Product/Process Change Notice (PCN)	
<input checked="" type="checkbox"/> Major Change <input type="checkbox"/> Minor Change	
PCN Number: PCN_ConCARD_20250228 Affected Series: WR-CARD Affected Part Number: 693022010811 693043020611 PCN Date: 2024-11-28 Effective Date: 2025-02-28	Change Category: <input checked="" type="checkbox"/> Equipment/Location <input type="checkbox"/> General Data <input type="checkbox"/> Material <input type="checkbox"/> Process <input checked="" type="checkbox"/> Product Design <input type="checkbox"/> Shipping/Packaging <input type="checkbox"/> Supplier <input type="checkbox"/> Software
Contact: Product Management Phone: +49 (0) 7942 - 945 5001 Fax: +49 (0) 7942 - 945 5179 E-Mail: pcn.eican@we-online.com	Datasheet Change: <input checked="" type="checkbox"/> Yes <input type="checkbox"/> No Attachment: <input type="checkbox"/> Yes <input checked="" type="checkbox"/> No

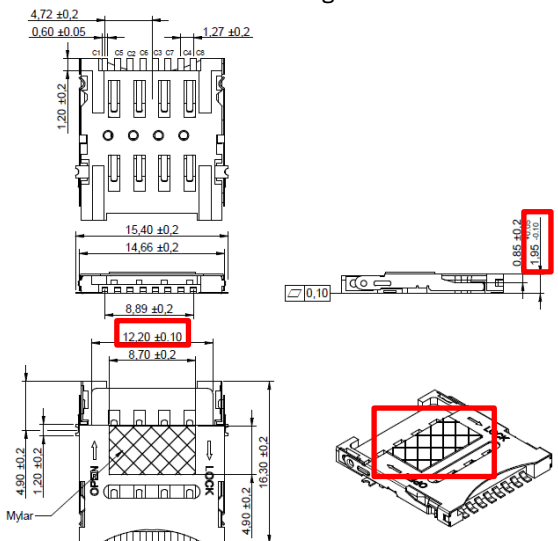
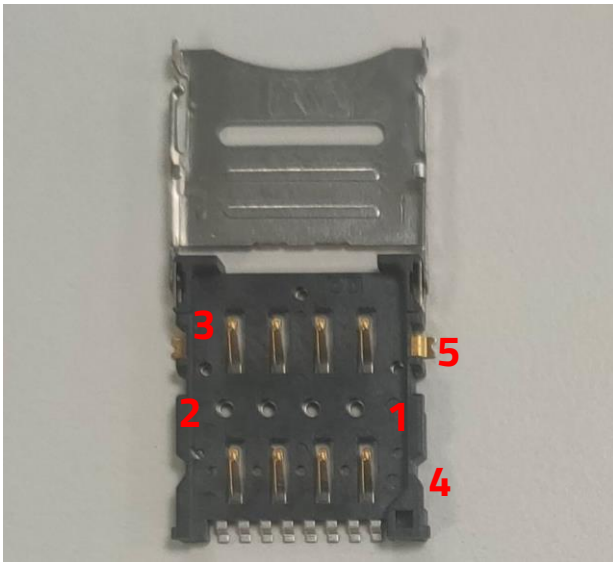
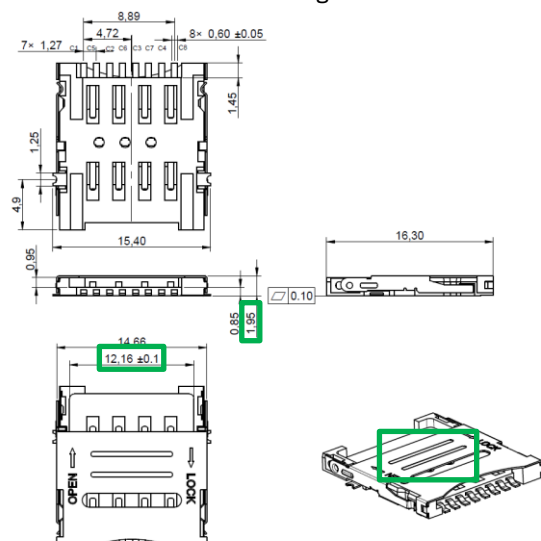
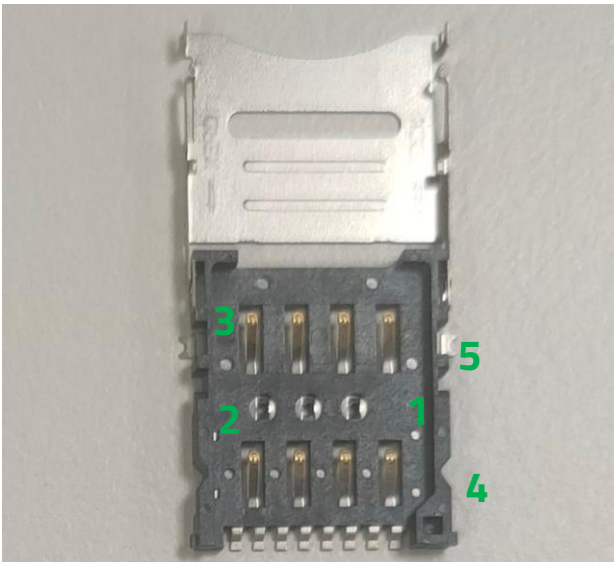
DESCRIPTION OF CHANGE: <p>In order to enhance the product reliability, Würth Elektronik eiSos is switching to a fully automated production line. There will be no change in function of the product.</p> <p>The new revision of the affected order codes will be sent out after the previous revision is out of stock (according to FIFO - first-in, first-out). The new parts will have 586xxx lot numbers.</p>	
Details of Change: 693022010811: <ul style="list-style-type: none"> - Optimization of the insert molding design <ol style="list-style-type: none"> 1. Improvement of the stress release gaps for improved coplanarity 2. Reduction in size of the punch-removed sprues, widening of the release gaps 3. Thickening of the contact leads for improved mechanical performances 4. Increased crispness of the lock ears to release the stress and wear on the hinge rotation axis during locking/unlocking 5. Change of plating on the solder tabs to selective gold - Removal of the stamped WE logo - Removal of the mylar due to better hinge coplanarity and pick and place compatibility of the process

Before Change	After Change
<p style="text-align: center;">Drawing:</p>  <p style="text-align: center;">Open view:</p> 	<p style="text-align: center;">Drawing</p>  <p style="text-align: center;">Open view:</p> 
<p>693043020611:</p> <ul style="list-style-type: none"> - Optimization of the insert molding design <ol style="list-style-type: none"> 1. Improvement of the stress release gaps for improved coplanarity 2. Better precision of the punch-removed sprues, with regards to the release gaps 3. Selective plating of the insert molding: thicker gold on contact, nickel overall, tin on solder pins 4. Lower contact tilting to reduce wear on the SIM card - Straightening of the shielding

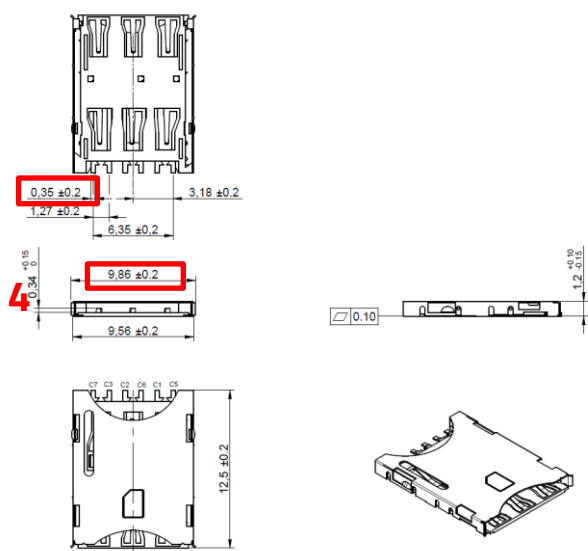
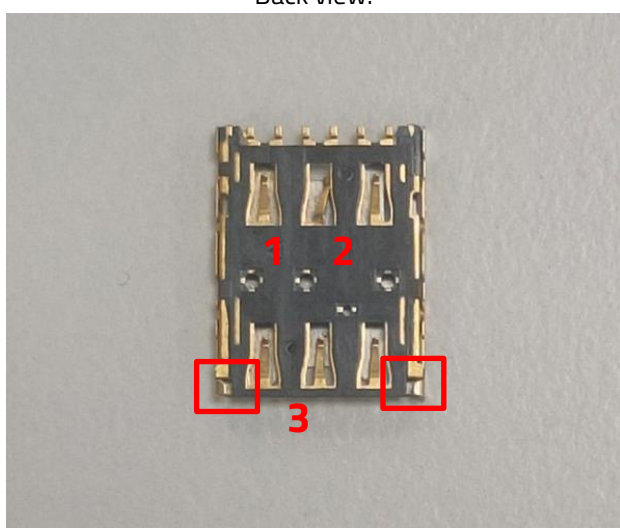
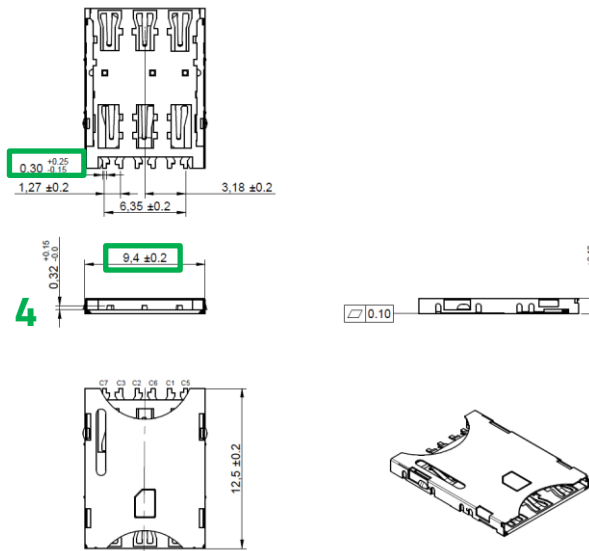
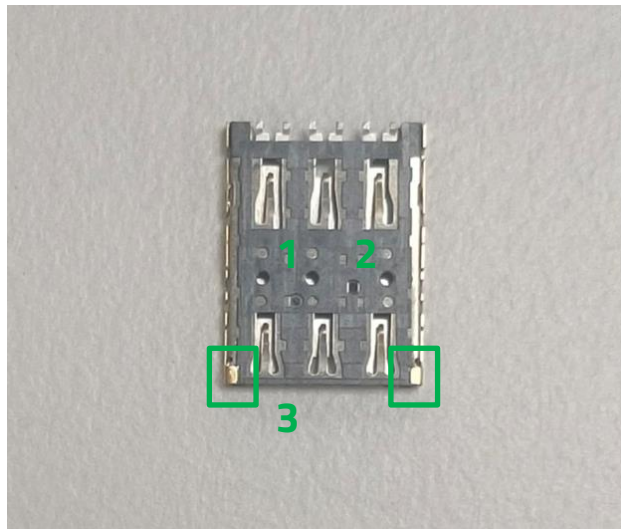
Before Change	After Change
<p style="color: red;">Drawing:</p>  <p style="color: red;">Back view:</p> 	<p style="color: green;">Drawing:</p>  <p style="color: green;">Back view:</p>
